ILLUSTRATIVE SITE DESIGNS
FOR
MULTI-FAMILY HOUSING IN PASADENA

Prepared for the Pasadena
Multi-Family Housing Task Force

Daniel Solomon and Associates
Daniel Solomon
Kathryn Clarke
Susan Haviland

DSA 48.8

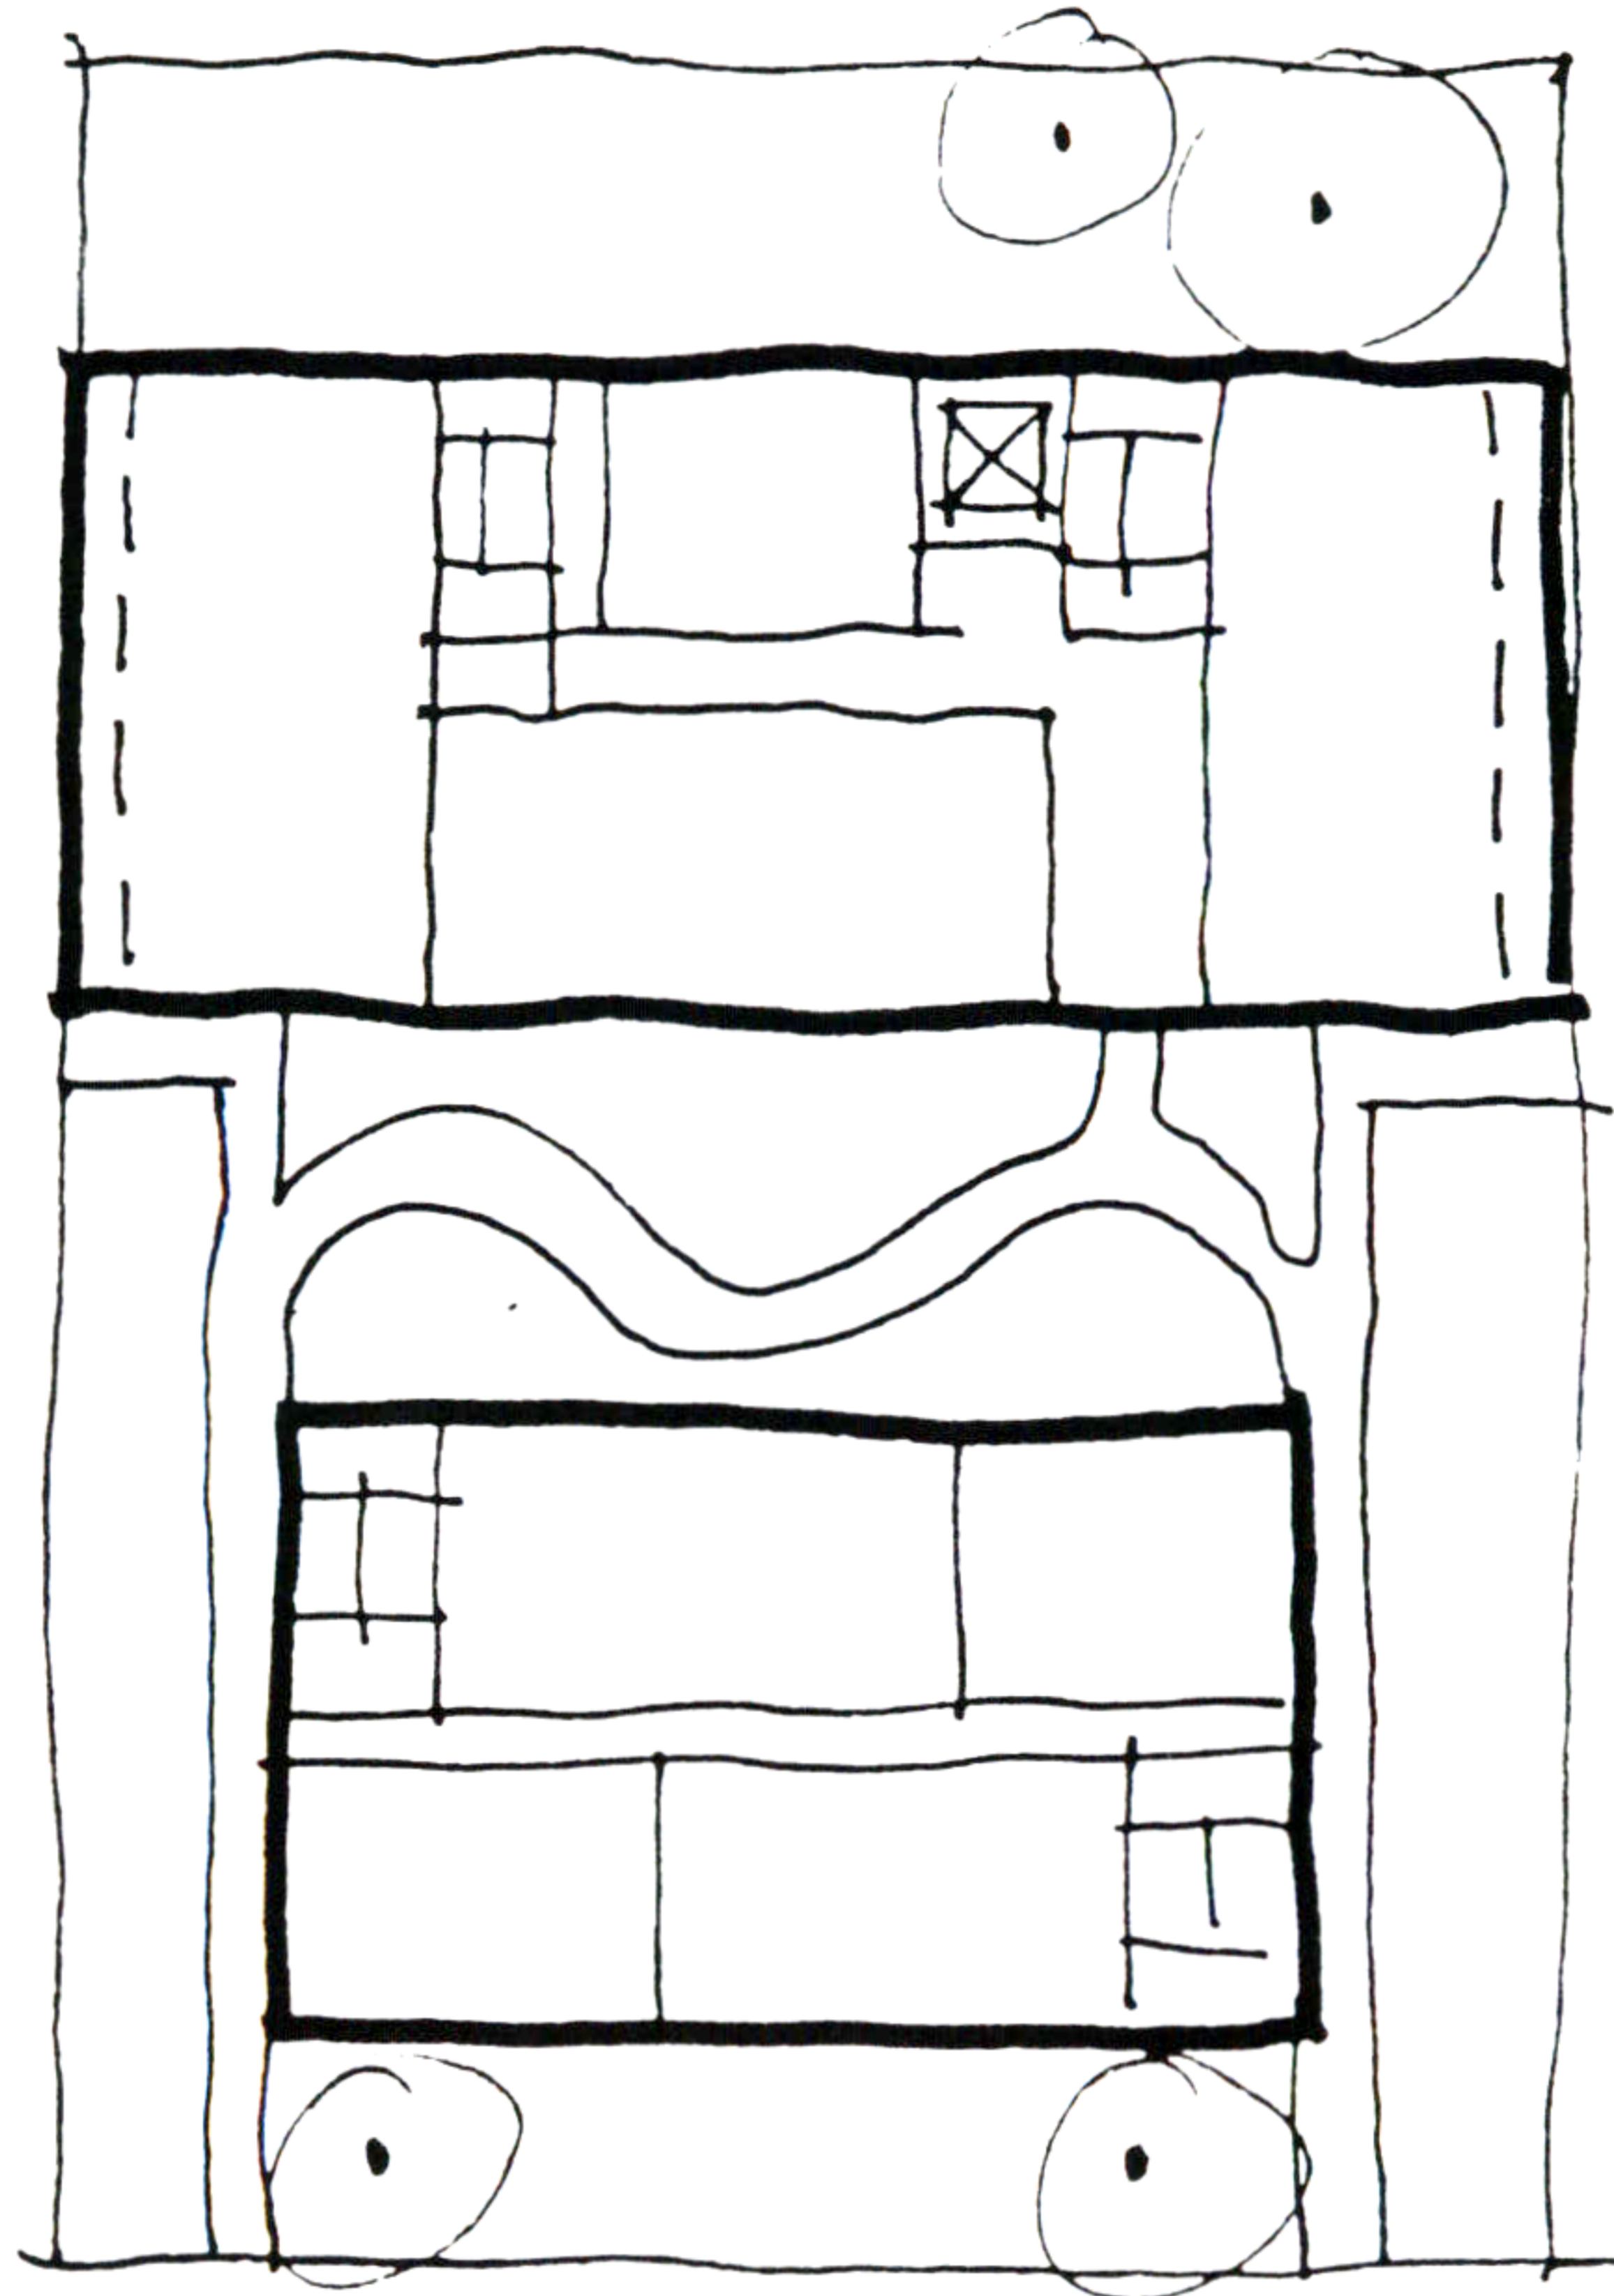
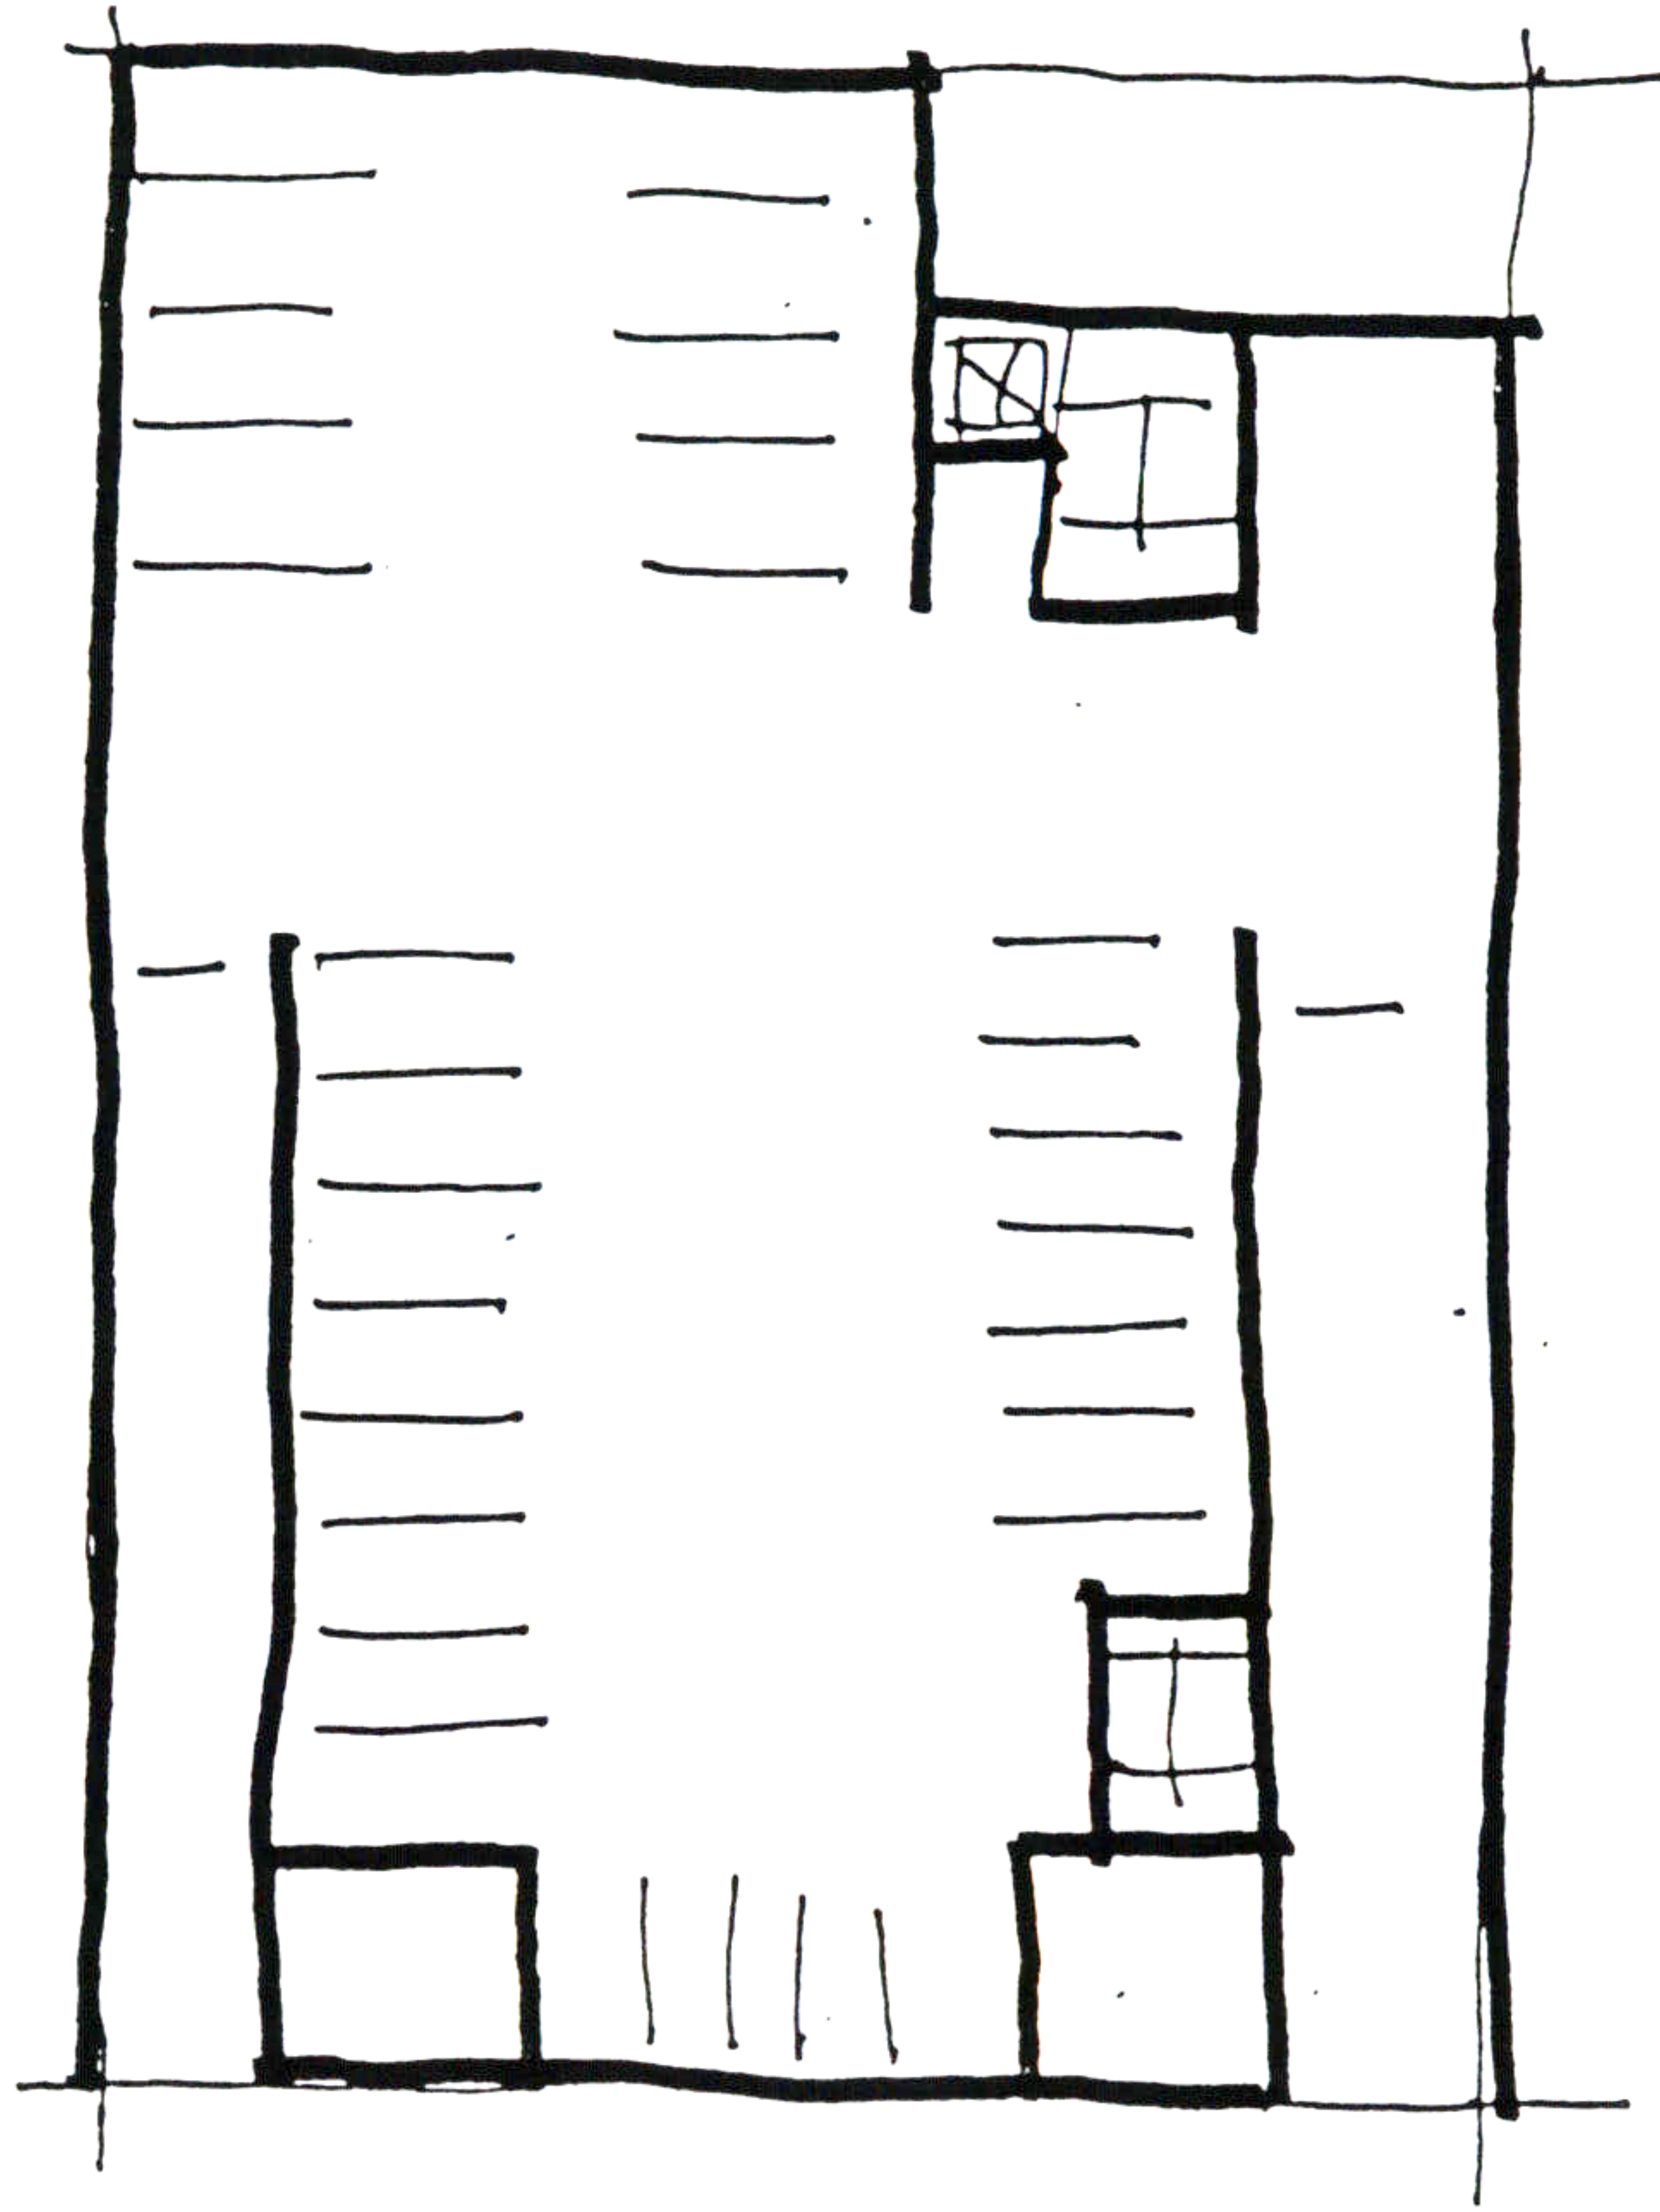
Not acceptable! Reduced ratio
